Advanced LIGO I & Q RF Demodulator (2 channel version)

DCC: [E1200113](#)

Design document

Title		
Audio Differential IF Amplifier		
Size: A	PCB DCC # D0902745	S
File: C:\Documents and Settings\costheld\My Document

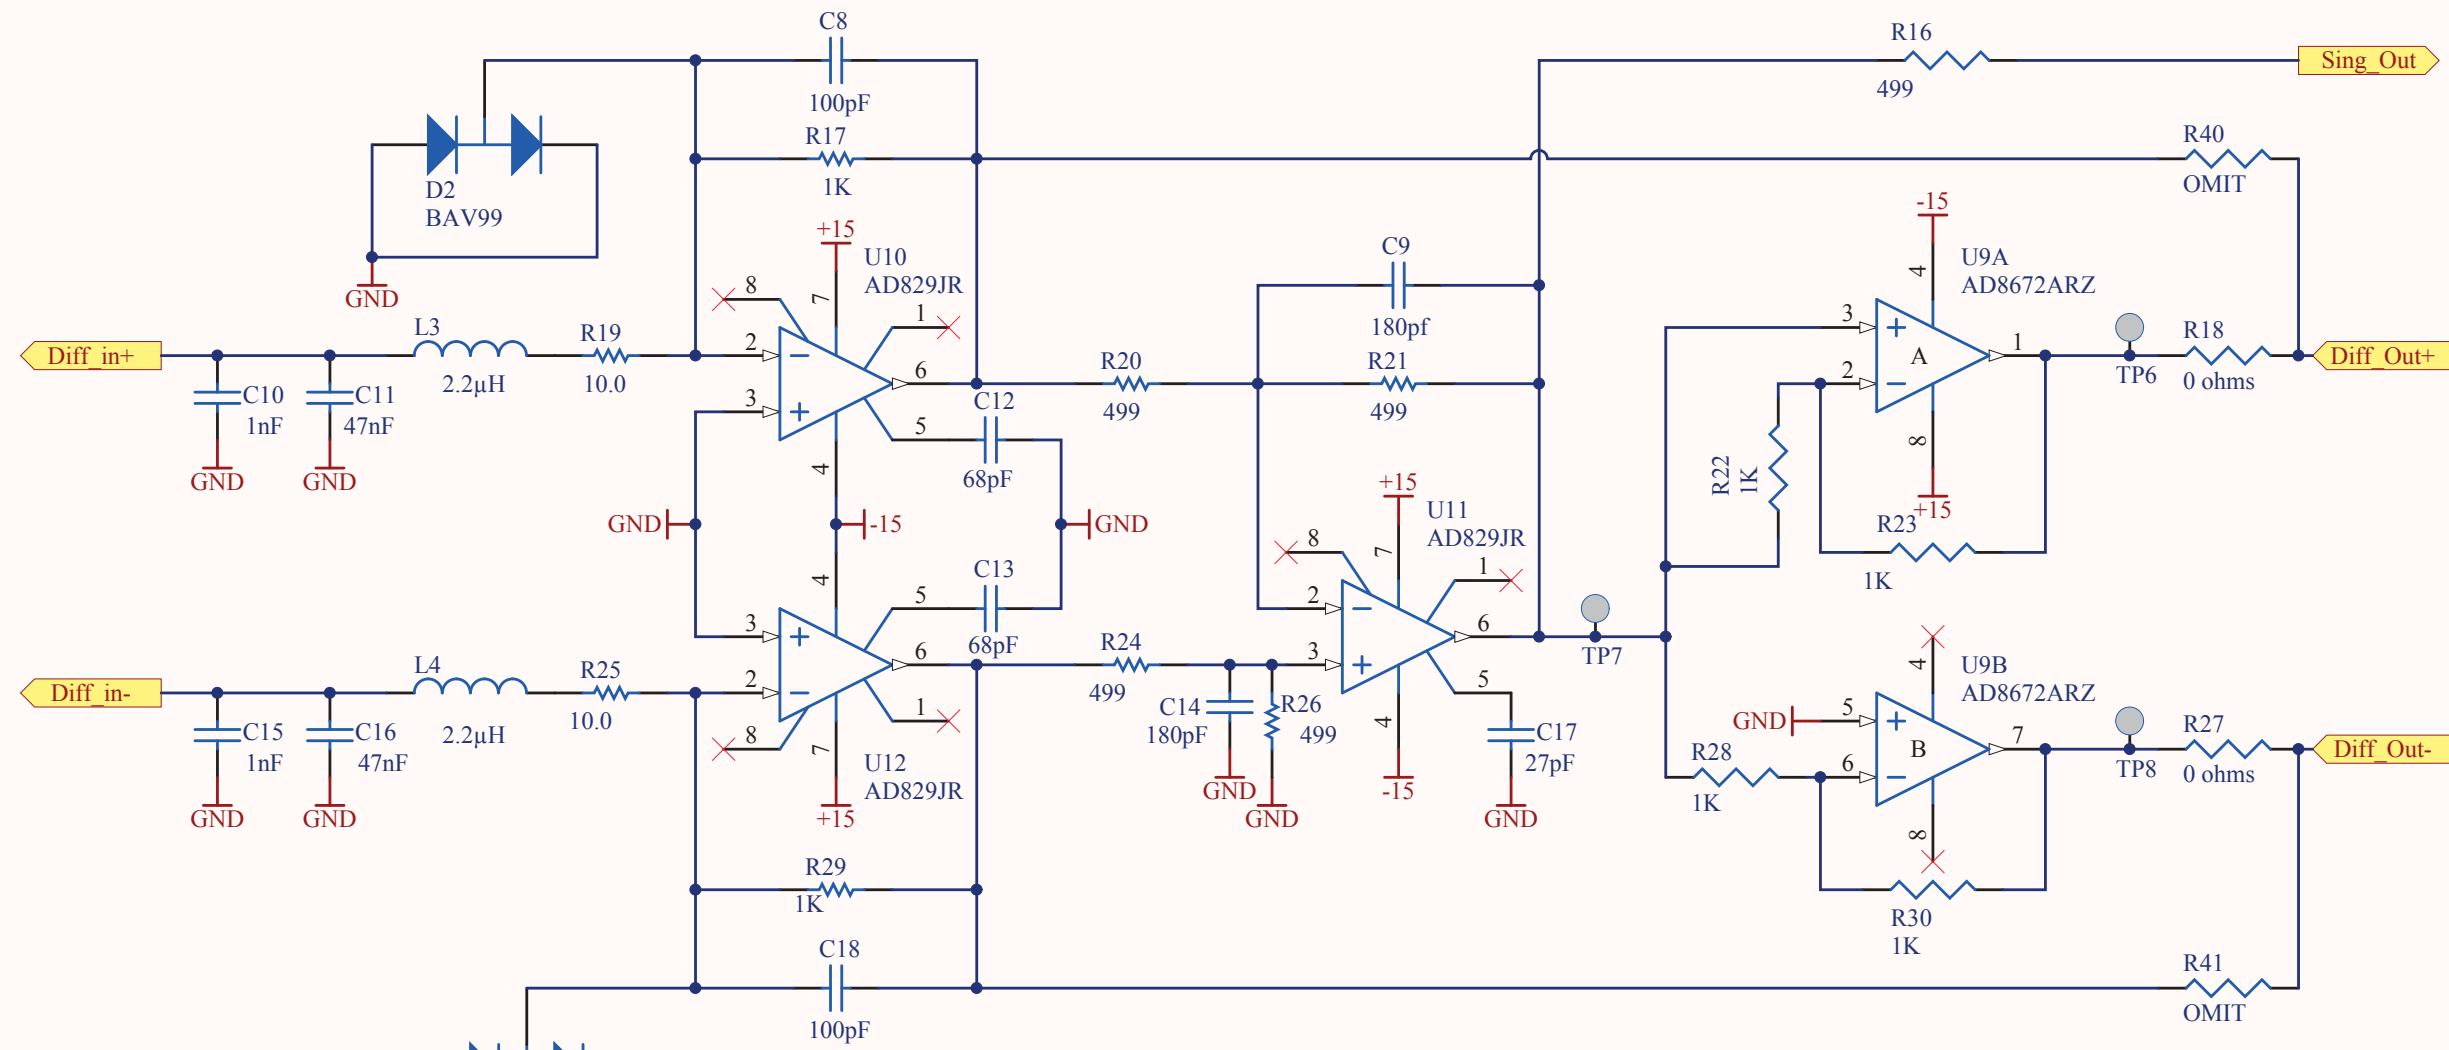
Fast option:
 C11/C16: 4.7nF, Mouser 77-VJ0805A472FXJTBC
 L3/L4: 220nH, Coilcraft 1206CS-221XGLB
 R18/R27: omit
 R40/R41: 0Ohm, Mouser 71-CRCW0805-0-E3

Ultra-fast option:
 C10/C15: omit
 C11/C16: 100pF, Mouser 81-GRM21A5C2E101FW01D
 C8/C18: 33pF, Mouser 77-VJ0805A330FXACW1BC
 C12/C13: 27pF, Mouser 581-08052A270JAT2A
 C9/C14: 10pF, Mouser 77-VJ0805A100FXAPW1BC
 R18/R27: omit
 R40/R41: 0Ohm, Mouser 71-CRCW0805-0-E3

aLIGO D0902745-v4 I&Q RF Demodulator

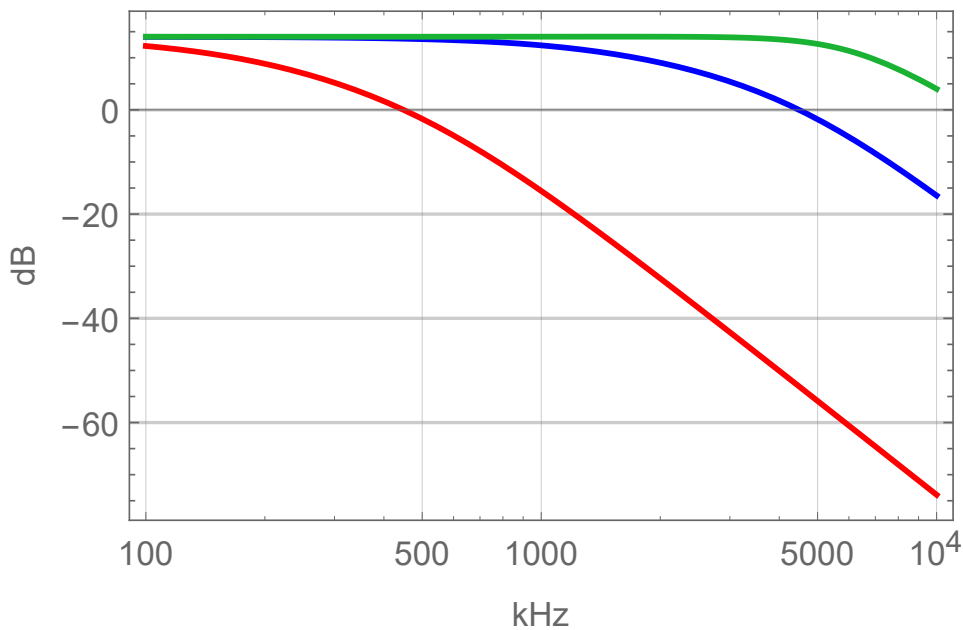
Fast option

Ultra-fast option
